# UNITED STATES PATENT AND TRADEMARK OFFICE

APPLICATION NO.	FILING DATE	FIRST NAMED INVENTOR	ATTORNEY DOCKET NO.	CONFIRMATION NO.
10/805,709	03/22/2004	Larry K. Harthorn	V2002036	9229

<b>Office Action Summary</b>	Application No. 10/805,709	Applicant(s) HARTHORN ET AL	
	Examiner John P. Fitzgerald	Art Unit 2856

## DETAILED ACTION

Fig. 6  
Agthoven

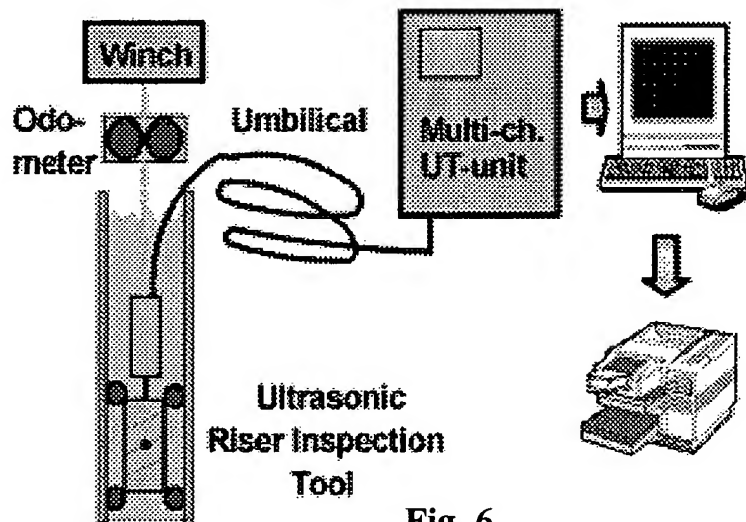
3. Claim 16 is rejected under 35 U.S.C. § 103(a) as being unpatentable over Applicant's disclosed Prior Art reference "Ultrasonic Inspection of Risers a New and Simple Approach" by Agthoven. Agthoven discloses a method of inspecting an drilling riser including the method steps of suspending/lowering the riser from a platform into seawater (see Figure 6 below) and allowing seawater to enter the riser (note: Agthoven discloses that seawater (or some other appropriate liquid) is necessary for safety reasons, wherein the crude is displaced according to a similar procedure as used for inspection of gas risers, as well as to allow for a proper "acoustical medium."); deploying an inspection tool/apparatus via a winch into the riser with a circular array of acoustical (ultrasonic) transducers; centralizing (from Fig. 6 below, it appears that the tool is centralized within the riser by four elements, however, Agthoven does not explicitly disclose this

detail, however, it is considered well known within the art that inspection tools are centered, to provide a 'constant' offset/distance, thus providing an "annular clearance" so that the acoustical emissions/receptions can be calibrated accordingly); and periodically (note: periodicity of any measurement technique is an inherent feature, since data is collected at a certain rate over time) causing the transducer to emit an acoustical signal through the seawater in the annular clearance and detecting a return acoustical signal from the wall of the riser.
